1985  
EDDY CURRENT EXAMINATION MANUAL FOR  
HOUSTON LIGHTING AND POWER COMPANY

South Texas Project  
Unit 1

IE Document No.: 85-030

HL&P Comments on  
BAW Drawing 1157654A  
"Cal. Standard"

FIGURE 1 - TUBE SUPPORT PLATE LOCATION AND NUMBERING SEQUENCE FOR E2  
RSG's.

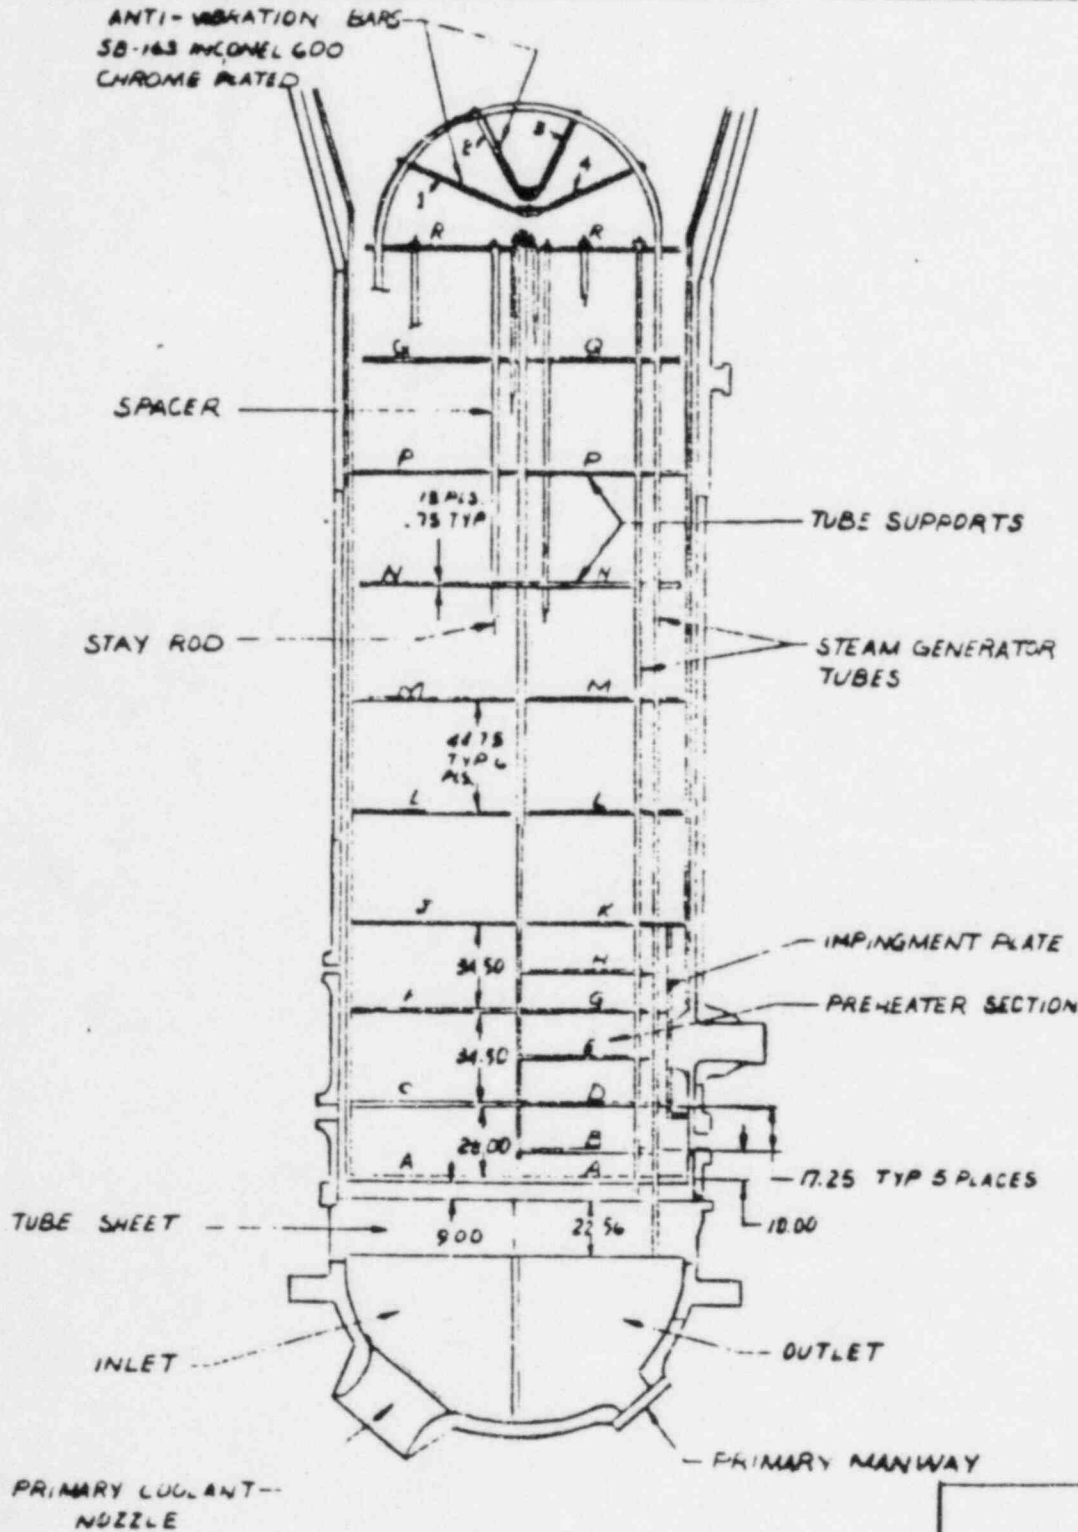
<u>Comment No.</u>	<u>Comments</u>
1	The procedure must be approved by B&W before use.
2	In Paragraph 4.6.1, "strainght" should be "straight".
3	In Paragraph 4.6.3, "Figure 1" should be "Figure 3".
4	Figure 1 should be included before use.
5	The nominal wall in Paragraph 1 should be ".043 inch".
6	The location of Row 1 Col 1 should be clarified in the text of 5.2.
